6.2 305 &307 - 309 CLARENDON STREET, SOUTH MELBOURNE

1. PURPOSE

- 1.1 To determine an application (776/2018/A) to amend an existing planning permit, which includes adding a further level (from six to seven storeys) to the approved rear addition, a new pergola at level 3, new plant area and to modify the ground floor access along Bank Street (demolition of an existing column and retention of the ironwork).

View O4 - Looking East along Bank St

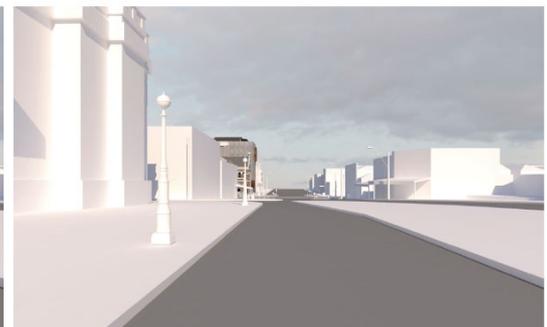
The view (view 04) from the South Melbourne Town Hall is considered to be minor.

Whilst the additional floor would be visible from the front of the South Melbourne Town Hall, the minor increase in height combined with the distance to the subject site of over 120 m, would have little perceived visibility over the already approved building. When viewed from the South Melbourne Town Hall the proposed level would read as a minor addition, that would marginally change the appearance of the development from both Clarendon and Bank Street. It would have no real impact on the heritage character of the place. Moreover, when standing in the location of View 04, as identified in the

Image: Additional demolition.

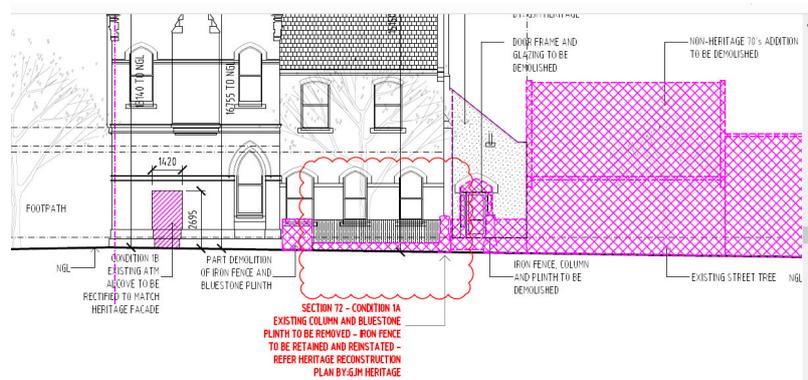
The additional demolition would be minor and consist of a column and bluestone plinth at ground floor level to the bank, facing Bank Street. The demolition of the column is required to achieve DDA compliant access.

Council's Heritage Advisor has noted that the brick column is not a part of the original fabric and therefore does not object to its demolition and the associated amendment of Condition 1a. (Refer Amended condition 1a)

- In regards to the plinth, we had agreed that the plinth was to stay and visually remain from the street face, but internally (on the inside facing the building) it would need to be cut back to allow for the width required for DDA access.
- That is, the protruding bluestones into the pathway would need to be removed (including the steel, curved prop that supports the fence and sits on this bluestone), plus the plinth reduced in depth by approx. 50% to provide the required path width.
- In addition, we were to re-attach the fence to the plinth, but would find a different way to anchor it, as the current supporting struts protruding into the pathway are to be removed for DDA access.

It is also noted that the plans currently state that the bluestone plinth is to be removed. Council's Heritage Advisor has reviewed the details above and has no objection to these works provided the note on the plans is amended to reflect the above details and confirm the bluestone plinth is to be retained. (Refer condition 1n)

- n) **A notation on the plans confirming the bluestone plinth to be removed and reinstated and the notation to include the following details:**
 - I. **The plinth to stay and visually remain from the street face frontage, but internally (on the inside facing the building) to be cut back to allow for the width required for DDA access.**

- II. **The protruding bluestones into the pathway to be removed (including the steel, curved prop that supports the fence and sits on this bluestone), plus the plinth reduced in depth by approx. 50% to provide the required path width.**

III. Re-attach the fence to the plinth, but in a different way to anchor it and remove the current supporting struts protruding into the pathway to allow DDA access.
